**PB# 06-32**

**Vails Gate Business Park**

**TOWN OF NEW WINDSOR**  
**PLANNING BOARD**  
**REVIEW COMMENTS**

**PROJECT NAME:** VAILES GATE BUSINESS PARK  
(REDEVELOPMENT OF TARKETT SITE)  
**PROJECT LOCATION:** OFF NYS ROUTE 94  
SECTION 69 – BLOCK 4 – LOT 3  
**PROJECT NUMBER:** 06-32  
**DATE:** 9 MAY 2007  
**DESCRIPTION:** THE APPLICATION PROPOSES THE REDEVELOPMENT OF THE FORMER TARKETT FACILITY (APPROX. 36 ACRES TOTAL LAND AREA) WITH GENERAL MANUFACTURING, INDUSTRIAL PROCESSING, AND SELF-STORAGE. THE PLAN WAS PREVIOUSLY REVIEWED AT THE 13 DECEMBER 2006 AND 25 APRIL 2007 PLANNING BOARD MEETINGS.

**CONCEPTUAL IMPROVEMENT PLAN**

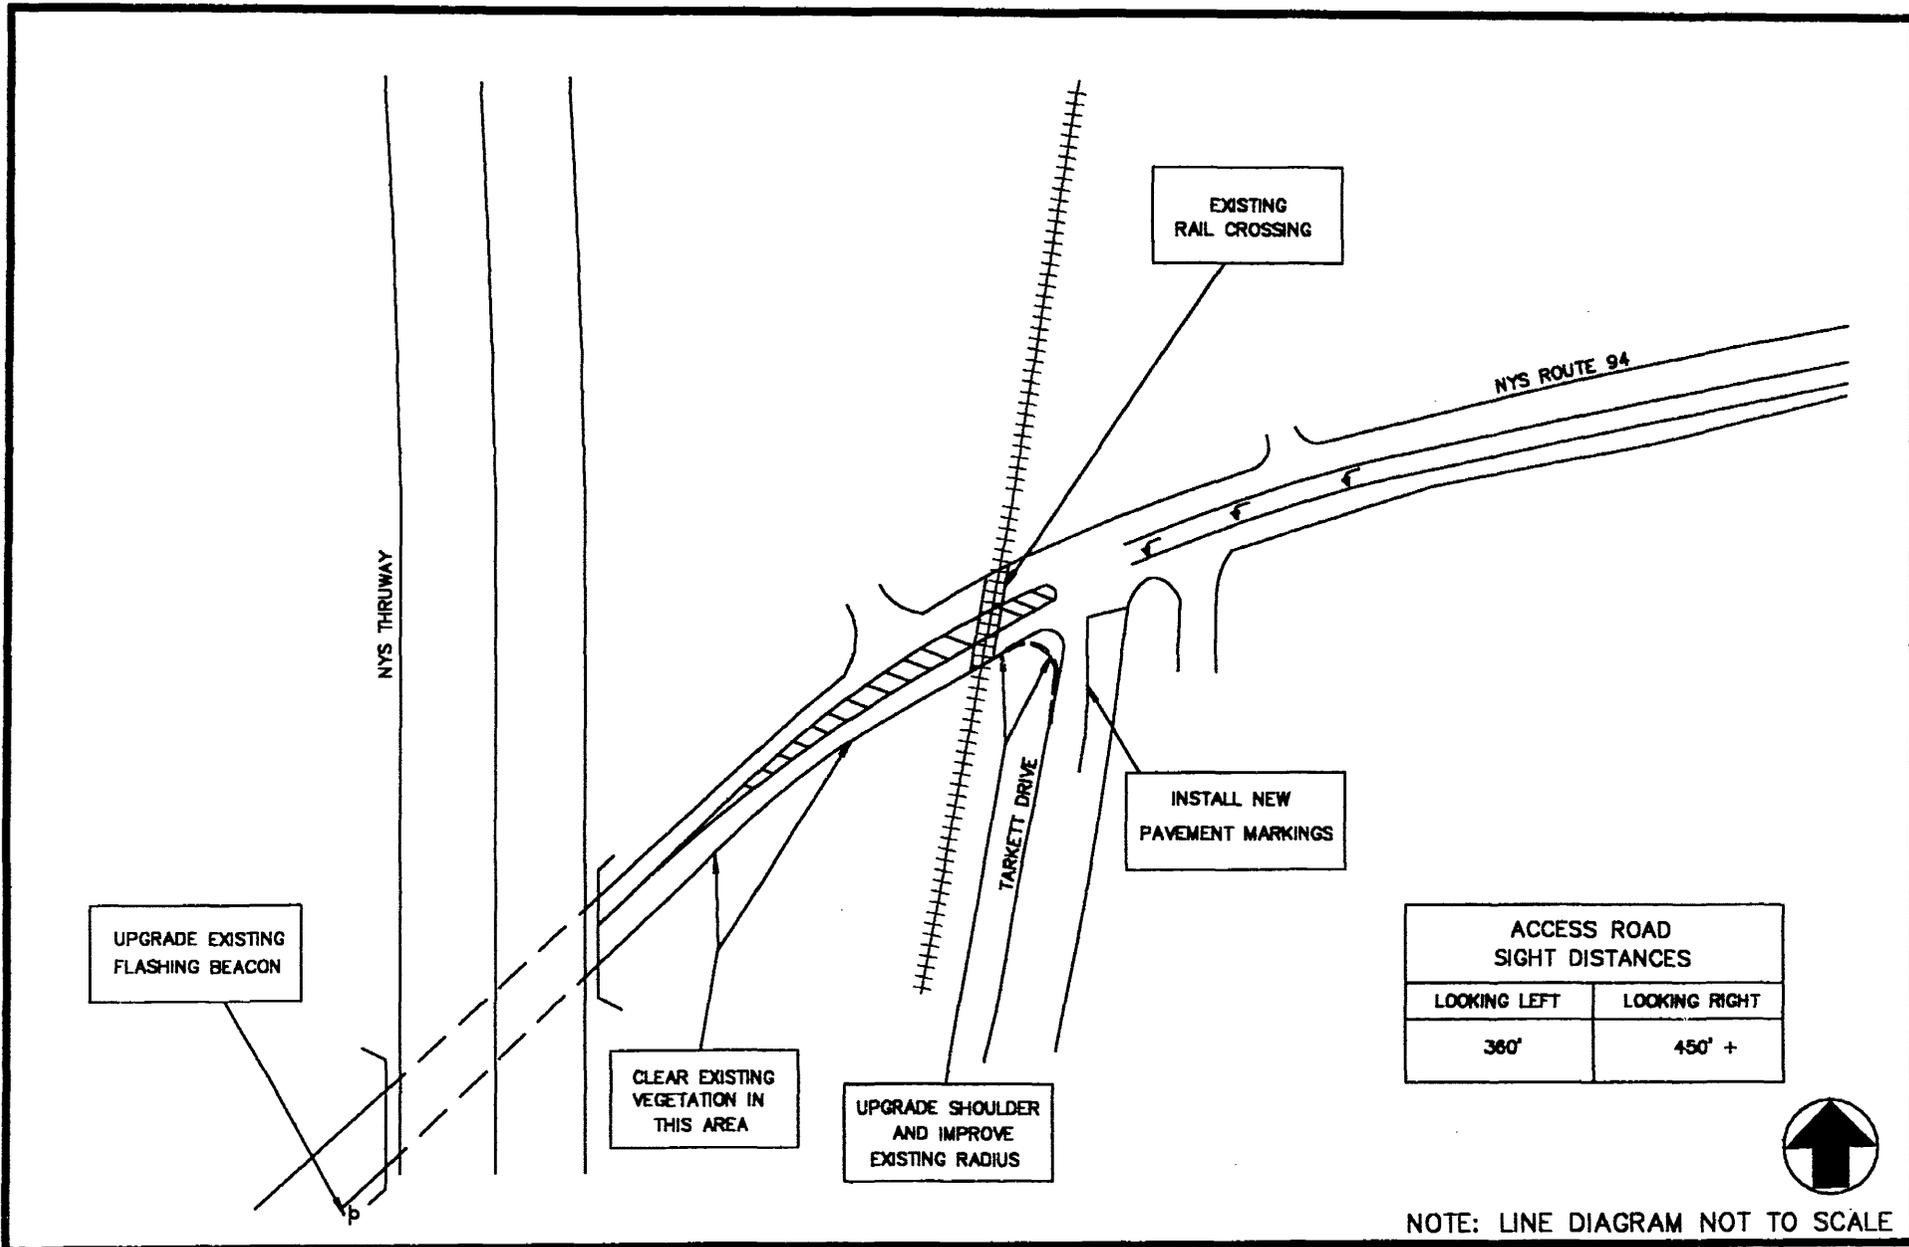
6. A conceptual plan has been prepared for access improvements in addition to Item 5 (see Figure No. 1A). These will also be coordinated with the New York State Department of Transportation as part of a Highway Work Permit.

7. The sight distances at the entrance drive are shown on Figure 1A. The sight distance improvements will ensure that the sight lines are kept clear during all times of the year. This distance is consistent with the NYSDOT stopping sight distances.

**HANDICAP PARKING SIGN DETAIL**

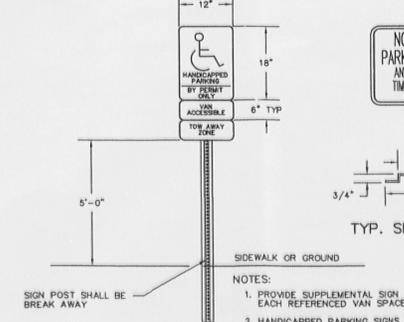
- The handicapped spaces depicted on the plans do not meet State Code requirements relative to access aisles and signage. (detail is also incorrect).

**60 DEGREE PARKING LAYOUT**

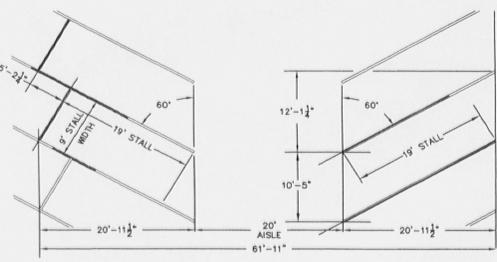
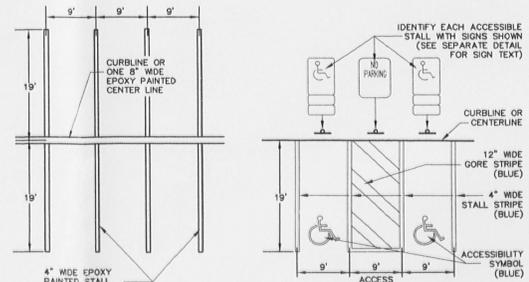
- Parking space typical detail is duplicated on sheets SP5 and SP6. The dimensions indicated on detail sheet SP6 are incorrect. The details should specify minimum aisle widths.
